ADDENDUM NO. 3

**South Fountains Restoration
Missouri State Capitol Building
Jefferson City, Missouri
PROJECT NO.: 02204-01**

JUNE 3, 2025

OVERALL LANDSCAPE PLAN 01
SCALE 1" = 20'

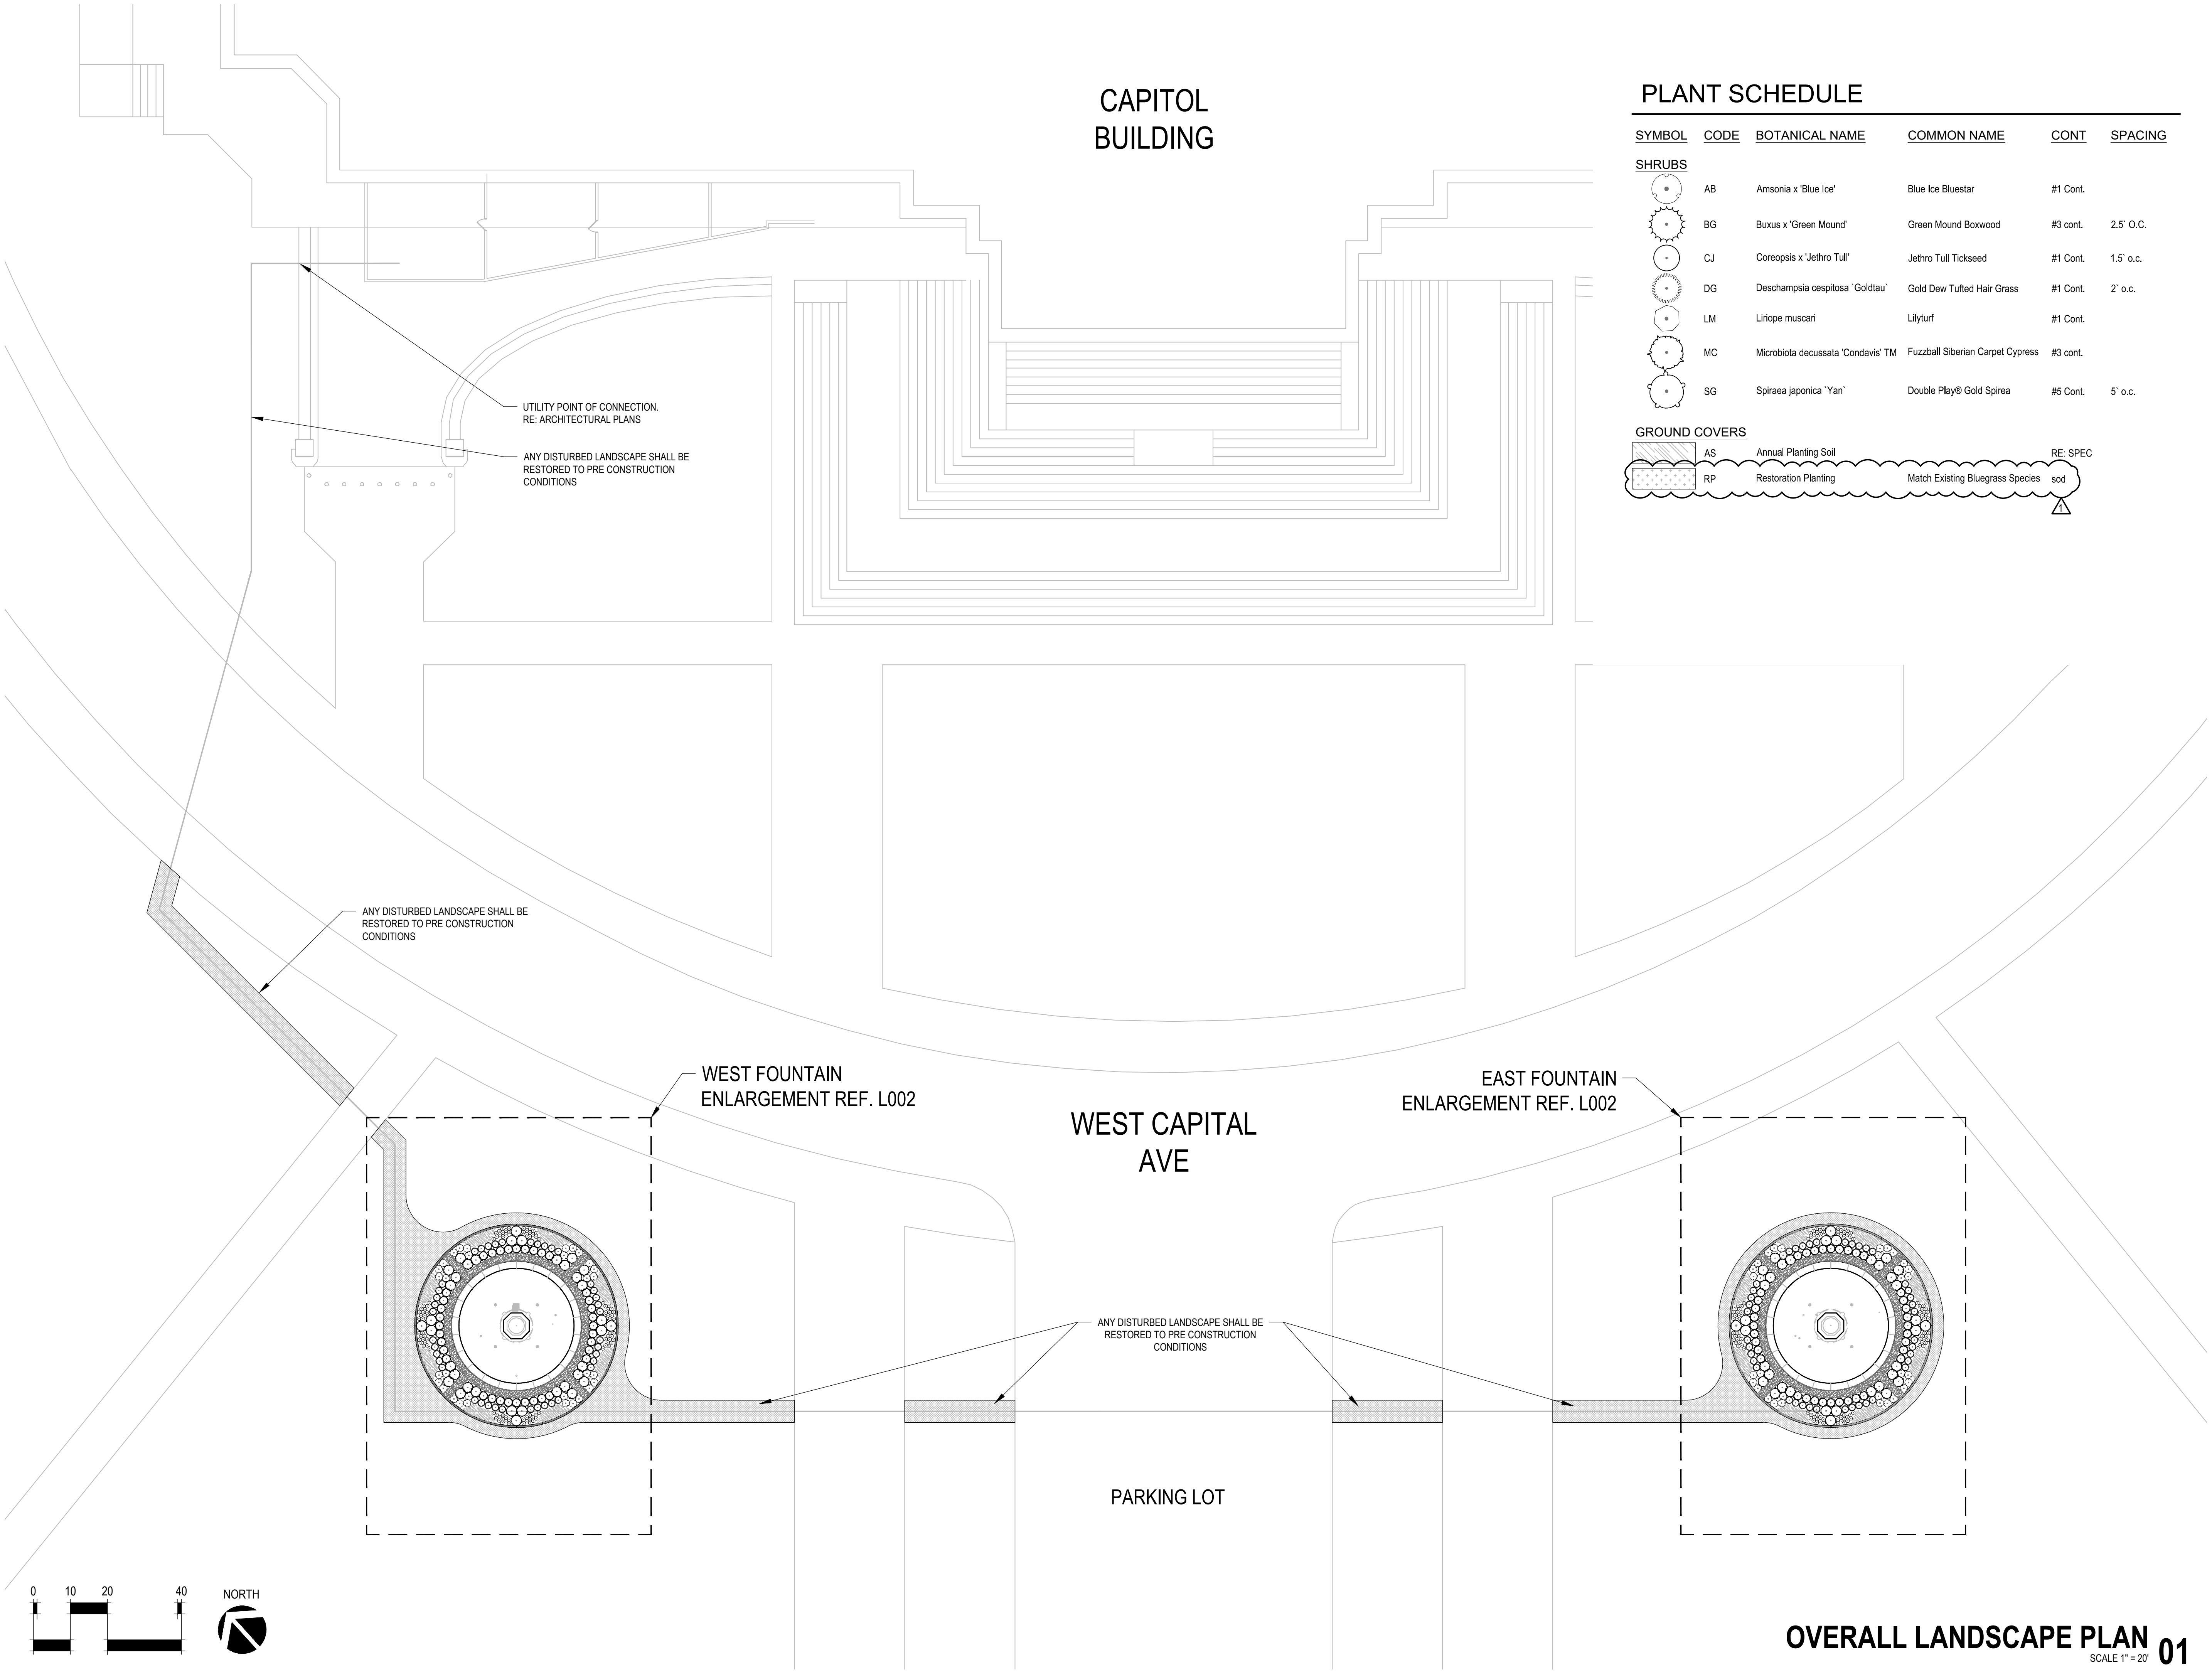
1. A topographic site plan has recently been provided by the Owner. Some of the revised drawings show this new content.
2. Sheet L001
 - a. REVISE overall plant schedule GROUND COVERS RP Restoration Planting, to include sod, not seed.

SYMBOL	CODE	BOTANICAL NAME	COMMON NAME	CONT	SPACING
SHRUBS					
	AB	Amsonia x 'Blue Ice'	Blue Ice Bluestar	#1 Cont.	
	BG	Buxus x 'Green Mound'	Green Mound Boxwood	#3 cont.	2.5' O.C.
	CJ	Coreopsis x 'Jethro Tull'	Jethro Tull Tickseed	#1 Cont.	1.5' o.c.
	DG	Deschampsia cespitosa 'Goldtau'	Gold Dew Tufted Hair Grass	#1 Cont.	2' o.c.
	LM	Liriope muscari	Lilyturf	#1 Cont.	
	MC	Microbiota decussata 'Condavis' TM	Fuzzball Siberian Carpet Cypress	#3 cont.	
	SG	Spiraea japonica 'Yan'	Double Play® Gold Spirea	#5 Cont.	5' o.c.
GROUND COVERS					
	AS	Annual Planting Soil			RE: SPEC
	RP	Restoration Planting	Match Existing Bluegrass Species	sod

WEST FOUNTAIN LANDSCAPE ENLARGEMENT 01
SCALE 1" = 5'

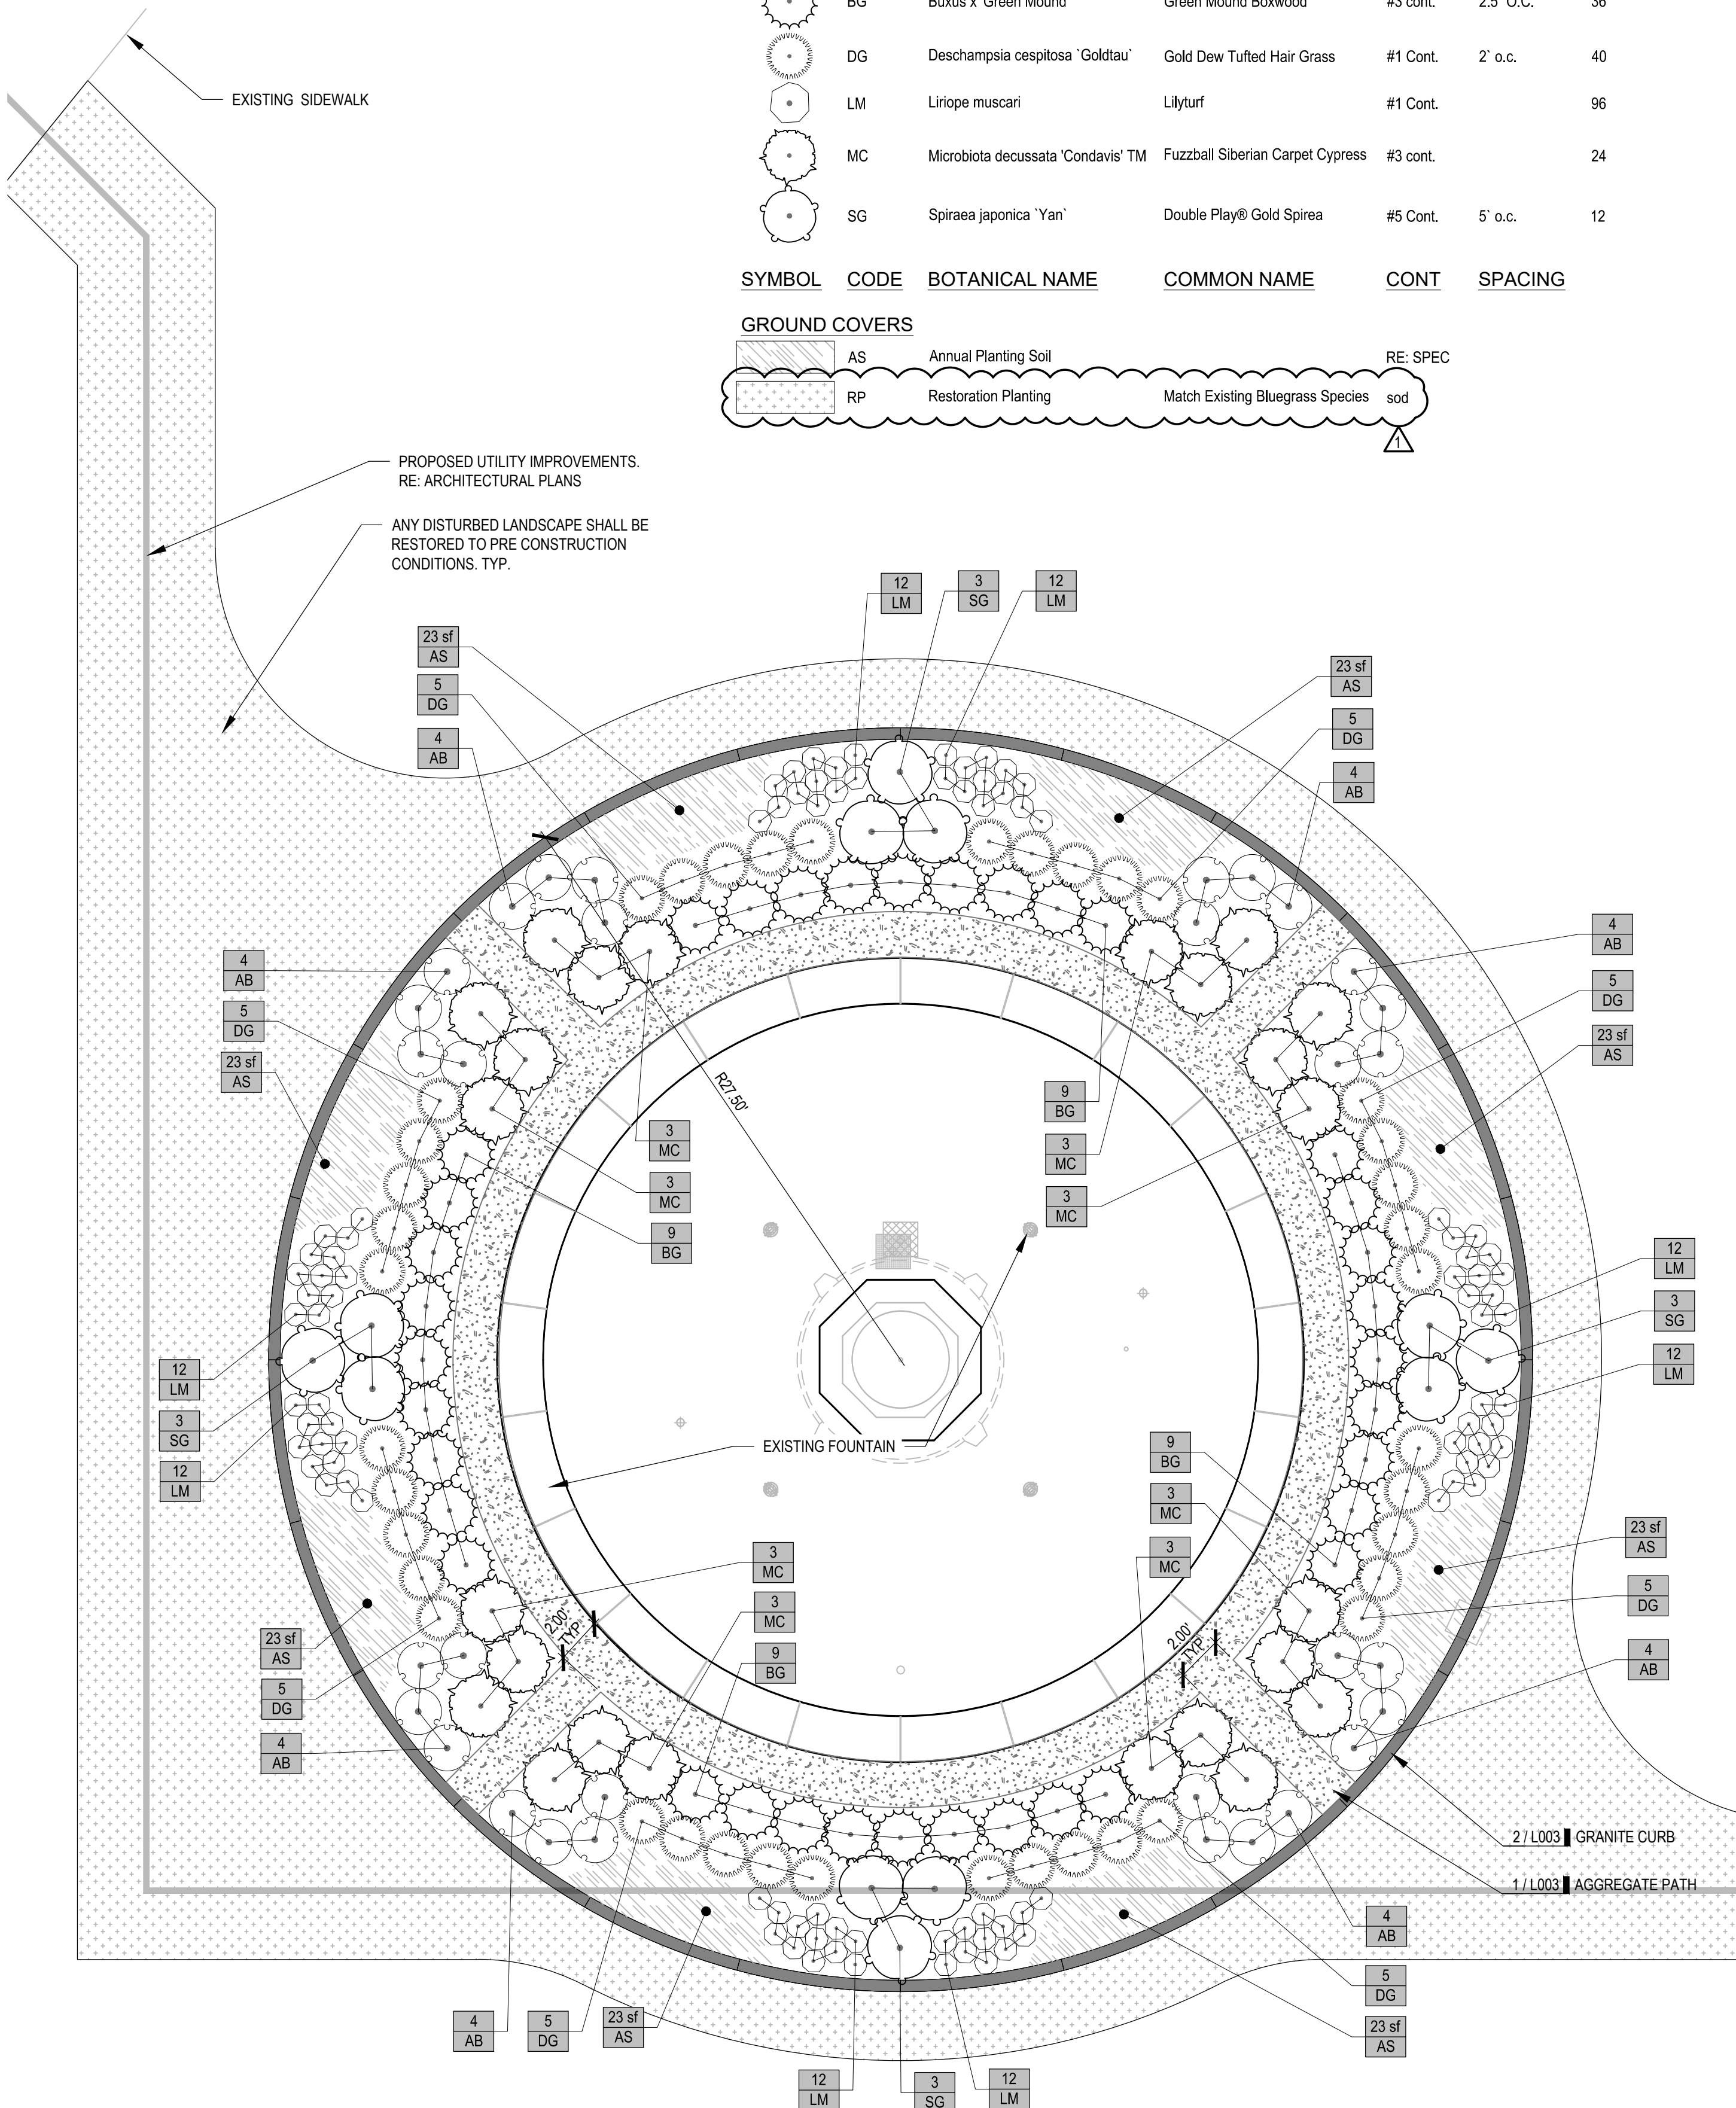
3. Sheet L002
 - a. REVISE West Fountain plant schedule GROUND COVERS RP Restoration Planting to include sod, not seed.
 - b. REVISE East Fountain plant schedule GROUND COVERS RP Restoration Planting to include sod, not seed.

GROUND COVERS					
	AS	Annual Planting Soil		RE: SPEC	
	RP	Restoration Planting	Match Existing Bluegrass Species	sod
